STOCKTON PLATEAU HYDRO SCHEME - S92 REQUEST FOR ADDITIONAL INFORMATION

West Coast Regional Council Information Request

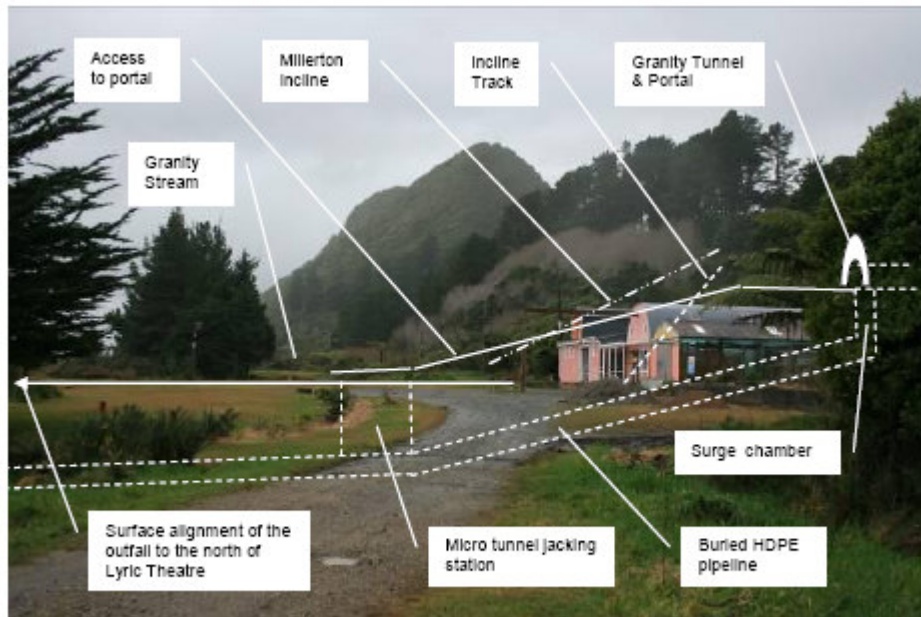
Provide a schematic diagram of the internal operating of the bulk head, machine hall for the proposed power stations

7.1 HDL Response

The power stations will be located in an underground chamber up to 150m from the tunnel portal. The internal layout of the power stations have no bearing on the assessment of environmental effects. Power station fitout will be a matter for final design and will be dictated by final decisions on installed capacity, among other things.
